## **REMARKS**

At the outset, the Examiner is thanked for the thorough review and consideration of the present application. The Office Action dated July 21, 2003, has been reviewed and its contents carefully reviewed. Claims 1-38 are currently pending in the present application, claims 10-14, 19-21, 27-31, and 35 having been withdrawn from consideration in view of the Election of Species Requirement dated March 26, 2003. Reexamination and reconsideration of the pending claims is respectfully requested.

FIG. 11A

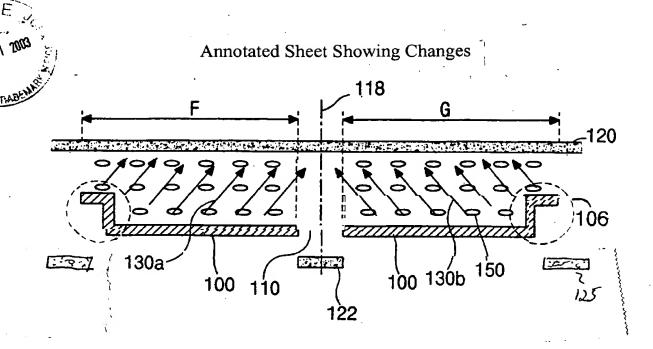
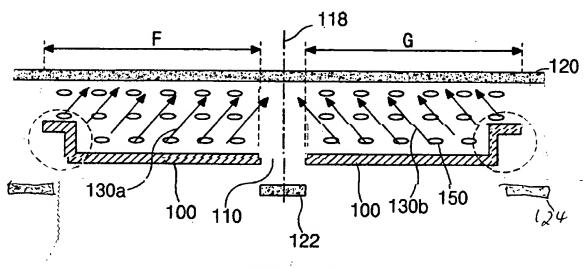
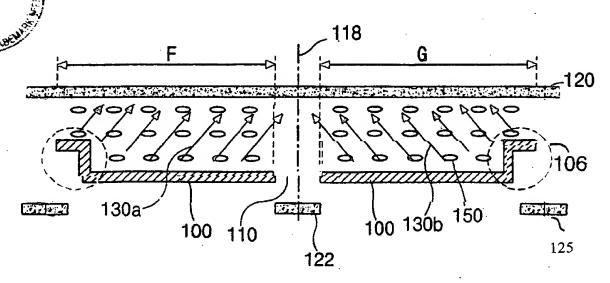
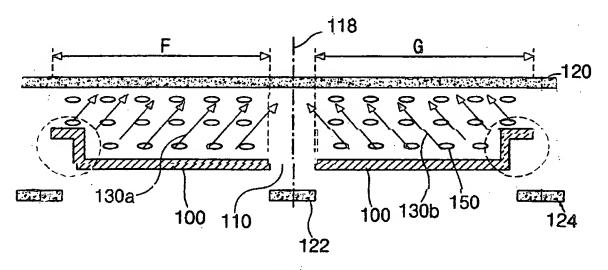
In the Office Action, the drawings are objected to under 37 C.F.R. § 1.83(a) as not showing every feature of the invention specified in the claims. Applicant hereby provides new Figures 11A and 11B to show the features recited by claim 5 of the present application. Both a replacement sheet and annotated sheet showing changes is included herewith.
